Access Compliance Report

Public Rights-of-Way

Intersection ID: 19934	Main Street: W_ARROWWOOD_RD	Cross Street: WHITEWHITEHALL_EXECUTIVE_CENTER_DR	Location: NW
ADA ID: F0E599C66254	Ramp Type: Perp	Initial Pass/Fail: Fail	Overall Compliance: No Severity Score: 46.25

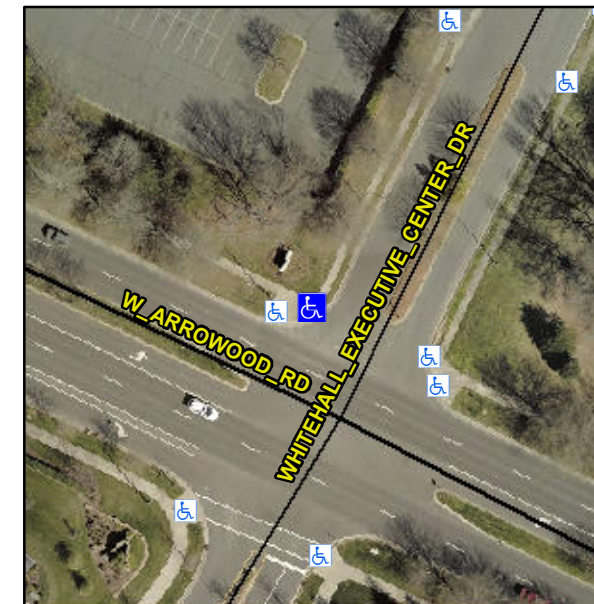
Not Found, R304.5.1, R304.2.2, R304.5.3

Compliance	Description	Data	Compliance	Description	Data
N/A	Ramp Length (in)	104.0	No	Ramp Slope (%)	9.5
No	Ramp Width (in)	47.0	No	Ramp XSlope (%)	10.7
N/A	Flare Type LT	N/A	N/A	Flare Type RT	N/A
N/A	Flare Slope LT (%)	N/A	N/A	Flare Slope RT (%)	N/A
N/A	Flare Traversable LT?	N/A	N/A	Flare Traversable RT?	N/A
N/A	Landing Length (in)	N/A	N/A	DWS Provided?	N/A
N/A	Landing Width (in)	N/A	N/A	DWS Contrast?	N/A
N/A	Landing Slope (%)	N/A	N/A	DWS Length (in)	N/A
N/A	Landing X Slope (%)	N/A	N/A	DWS Full Width?	N/A
N/A	Landing Curb? (Y/N)	N/A	N/A	DWS Offset (in)	N/A
N/A	Shared Landing?	N/A			
N/A	Gutter Ponding?	N/A	N/A	Gutter Slope (%)	N/A
N/A	Gutter Lip Ht (in)	N/A	N/A	Gutter X Slope (%)	N/A
N/A	Painted X Walk1?	No	N/A	Painted X Walk2?	N/A
	X Walk 1 Direction	To SE		X Walk 2 Direction	N/A
N/A	X Walk 1 Width (in)	N/A	N/A	X Walk 2 Width (in)	N/A
	X Walk 1 Slope (%)	7.8		X Walk 2 Slope (%)	N/A
	X Walk 1 X Slope (%)	7.4		X Walk 2 X Slope (%)	N/A

Remove & Replace Entire Ramp.
